AUDIT
REPORT

D08A ACC and BIE CCL Directories

All associated RSMs and schemas

Figure 1 – Requested e-Cert Message Assembly

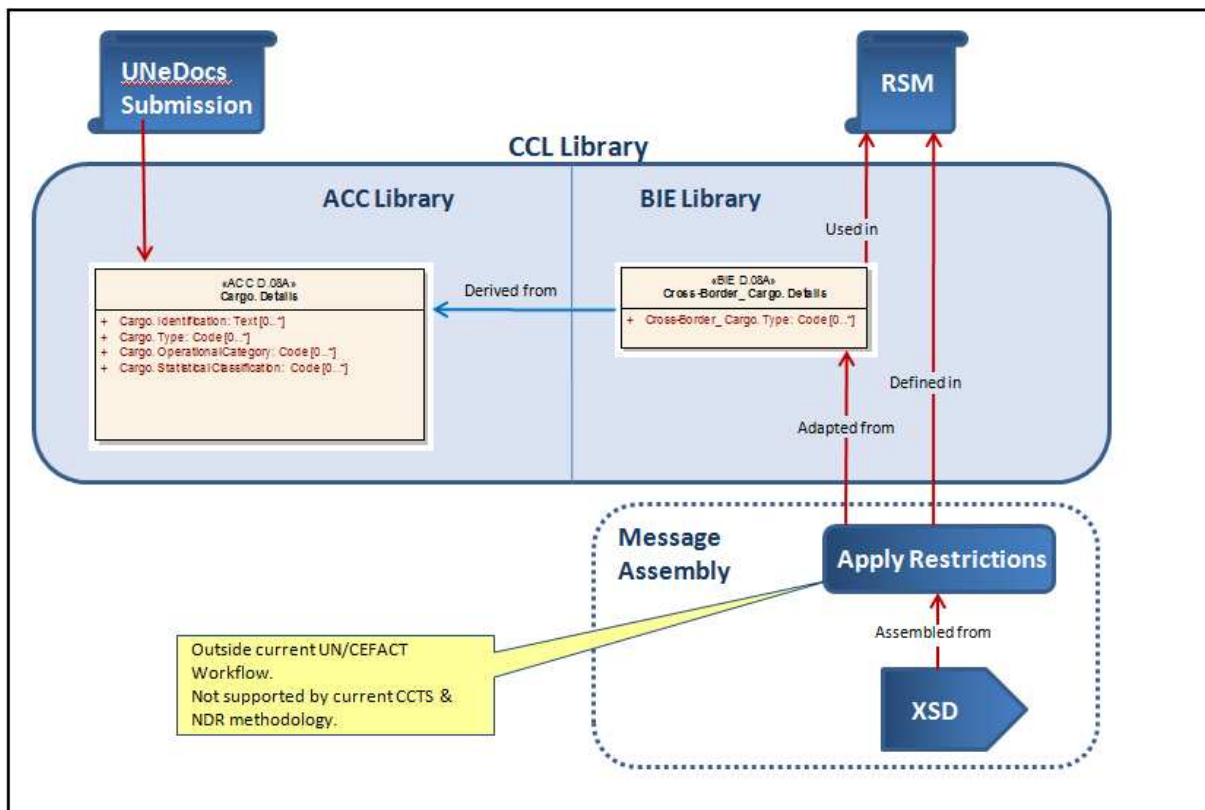
ICG: Applying further restrictions to CCL BIEs as part of message assembly is not in line with the UN/CEFACT message design methodology. All schemas are structured based on the normative form ABIEs as contained in the CCL, without further change or adjustment during message assembly.

Using one example CC from the e-Cert RSM, the issue can be illustrated as follows:

Figure 2 – D.08A Message Assembly

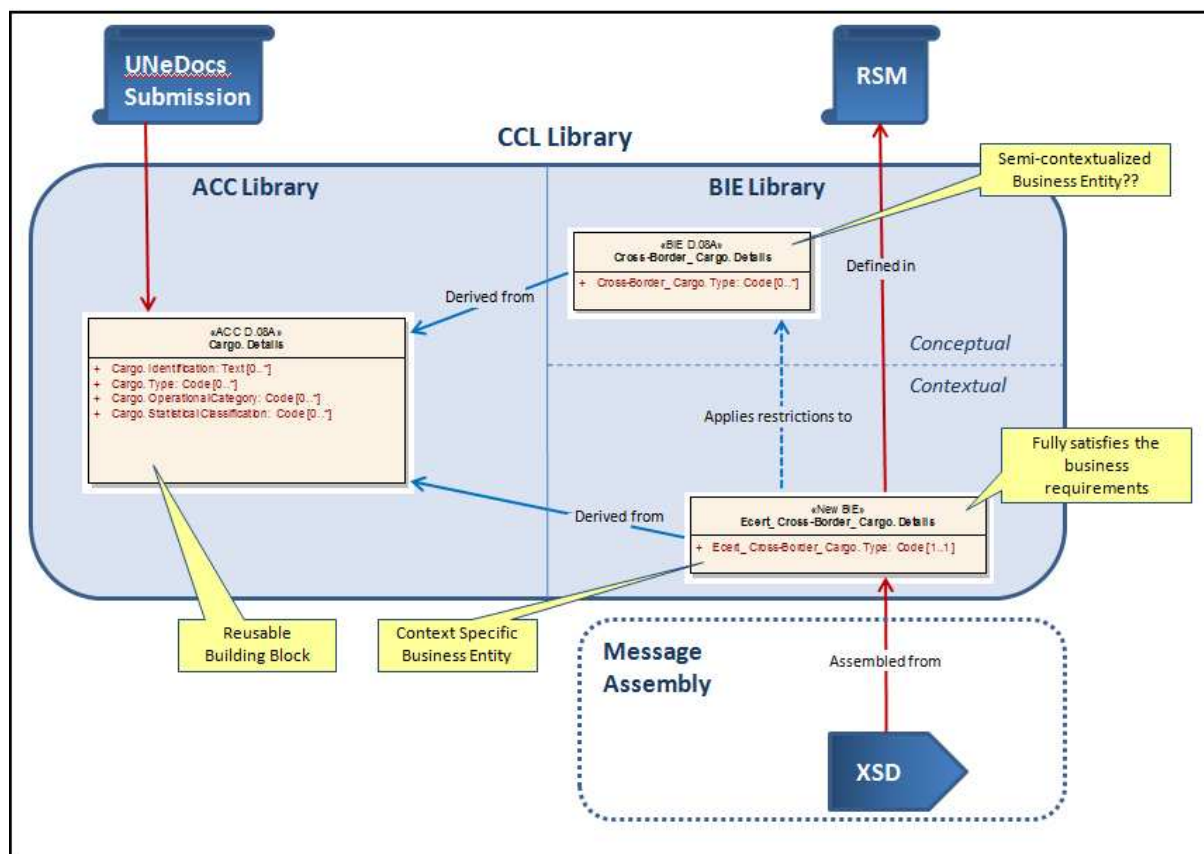
Using the same example CC from the e-Cert RSM, and respecting the current UN/CEFACT Workflow, CCTs and NDRs, the proposed solution can be illustrated as follows:

- It is noted that E-Cert is willing to make every effort necessary to harmonise their ABIEs but must have their business requirements met.
- In order to expedite the D.08A production, it is recommended that TBG17 revert to the original e-Cert submission, which respected the current UN/CEFACT methodology, with any adjustments necessary that do not bring its business requirements into cause. The harmonized BIEs representing the corresponding semantics in the UN eDocs data model already in D.08A will remain in the library.
- The e-Cert ABIEs are introduced imperatively in the D.08A CCL.
- ICG audit the revised CCL for conformity and any other problems are rapidly resolved to enable a speedy release of the D.08A CCL.
- ATG produce ASAP the D.08A schemas including that of e-Cert, based on the original, fully contextualized e-Cert BIEs.

i. **ABIE - SPS_ Cargo**

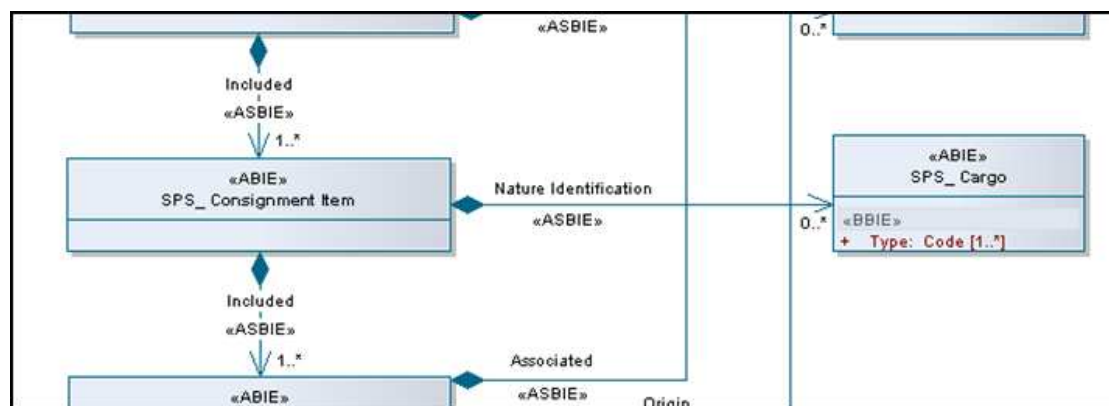
This ABIE has an unbounded association with *SPS_ Consignment Item* and has only one attribute which also has an occurrence of unbounded.

Recommend that the attribute SPS_Cargo. Type. Code be changed to have a cardinality of 1..1. Corrected
